## Mesa Public Library Noise Issues

## **Level 2 Meeting Rooms**

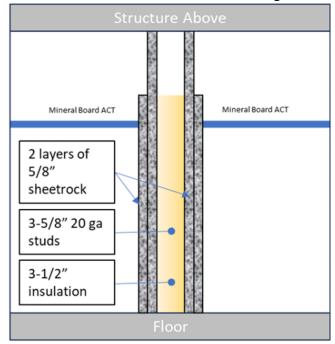
- Sound transmission between adjacent rooms when the operable partition are in use is poor.
- Speech intelligibility between meeting rooms relates to both the audibility of the intruding sound and the intelligibility of the speech itself.
- Eliminating the sound transfer entirely is not feasible with an operable wall.
- Over time the seals on the operable walls can become misaligned or degrade and no longer seal.

- It is recommended that the library contacts its local folding partition vendor (Modernfold is installed) to perform a maintenance inspection and to verify the integrity of the seals and wall panels.

- If this evaluation does not yield any noticable improvements the we recommend that the replacement of the existing partitions be considered.
- If replacement is the path forward, a newer option providing a higher level of sound isolation can be selected.

- We recommend that a partition with an STC-53 or better be selected.
  - This can be the Moderco Signature 800 or the Modernfold Encore
  - It should be noted that although operable partitions can be rated above an STC-50 they often perform 5-7 point lower than their STC rating once installed, due to various in-field conditions.

- The alternative is to replace the folding partitions with a fixed wall assembly.
   Although this would eliminate the flexibility of the space, the STC-55 assembly will achieve a superior level of acoustic noise reduction as compared to an operable wall.

# **Level 1 – Group SC Room & Small Study/Phone Rooms**

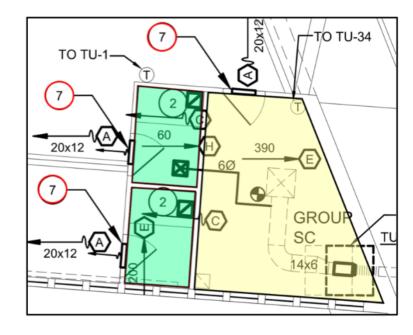
- Group SC Room: Elevated temperatures have occurred in this room prompting an increase in airflow to improve cooling. However, the added air volume is resulting in higher background noise levels in the room.

- Inter-room Noise Transfer: Sound is transferring between adjacent rooms. This occurs through 2 primary paths.
  - 1. Directly through the wall structure, which is dependent upon the performance of the assembly. (STC rating)

- 2. Indirectly thought the ceilings, where sound travel through the ceiling, over the top of the wall, and then enters the adjacent space through the ceiling of the neighboring room. (CAC rating)

- Noise Leakage to Public Areas: Sound from the enclosed rooms is also escaping into adjacent public spaces via the return air openings located in the walls. These openings are shown as red circled "7" in the layout. The return air openings are located within the walls or doors below the room's ceiling plane.

## Option 1: Improve Demising Walls & Extend Walls to Structure

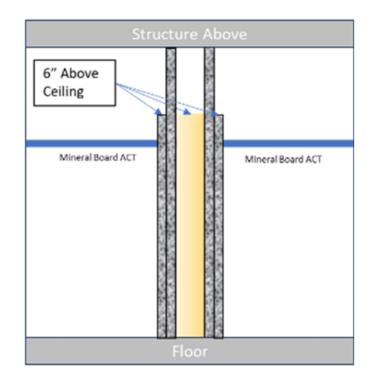
- Existing walls in most rooms were determined to be constructed using 1 layer of sheetrock on each side of 3-5/8" metal studs with no insulation in the stud cavity. This wall performs around an STC-35 to STC-40.
- · Walls are partial height and stop above the ceiling.
- The ceilings appear to be a mineral board ceiling tile which performs around a CAC-30 to CAC-35.
- With the open return grilles in the ceiling located close to one another, the performance through the ceiling is expected to be reduced. Therefore, the combined architectural separation between rooms is expected to be around an STC-35.

- Path1: Through the return air opening into the ceiling plenum and back down through the return air opening into Room 2
- Path2: through the ACT tile into the ceiling plenum and back down through the ACT tile into Room 2
- Path3: through the body of the wall

- Add insulation to the existing wall cavity. This can be done by removing the sheetrock on one side of the wall to add fiberglass or rockwool batt between the studs, or by keeping the sheetrock in place and blowing in loose insulation.
- Add 1 layer of 5/8" GWB on each side of the existing wall, for a total of 2 layers per side.
- Extend one layer on each side of the wall to the underside of structure. This can either be done on top of the existing layers, or by taking the new outer layers full height.

## **Ground Level – Young Adult Reading Area**

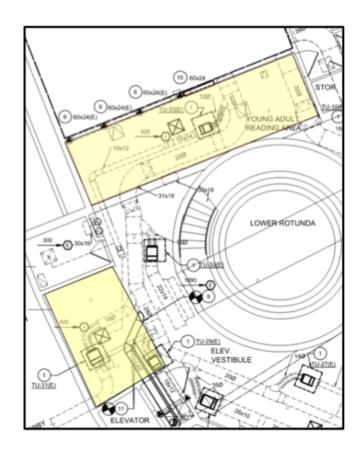
- Elevated background noise levels are present within the areas shown in yellow.
- This appears to be due to excessive airflow. When standing in these locations, one can feel a strong air current and observe nearby decoctions visibly moving, indicating high velocity air movement in the space.

- The background noise levels was measured to be 59 dBA (NC-52) which is substantially above the recommended background noise level of library reading zones of 35 dBA (NC-30).

- The Test & Balance Report dated February 25, 2019 was reviewed as part of this investigation and was assumed to be the final version.
- However, upon examination, several items listed on pages 8-10 remain unresolved.
   These include:

- Terminal units TU-33 and TU-31, located above the Reading Area per plans, are reported as balanced to maximum airflow rates of 1120 cfm and 2195 cfm respectively.

- But based on the pronounced airflow and movement of hanging elements in this
    area, it is likely that the actual airflow and associated airflow velocities in these
    zones are exceeding the reported values.

- It is also conceivable that the air reaching the Group SC Room on Level 1 is impacted by the amount of air being lost over the Youn Adult Reading Area, resulting in less air available to cool this room and possibly other rooms in the library.

#### Wall Openings

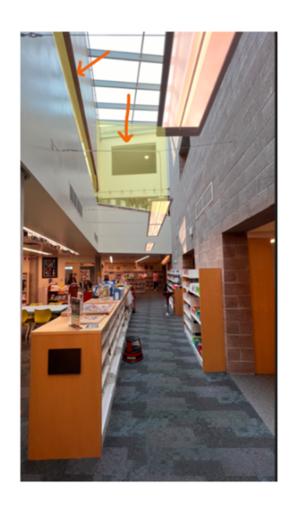
- Multiple openings in the circular walls of the rotunda permit sound to travel into adjacent areas of the library
- Blocking these opening with glass will substantially reduce noise transfer from the rotunda to surrounding spaces.
- The closure of these openings must be carefully coordinated with the building's HVAC airflow dynamics and fire/smoke evaluation requirements to ensure compliance with safety standards and to maintain proper ventilation.
- If closer of the openings is possible, the glass should be 3/8" thick.
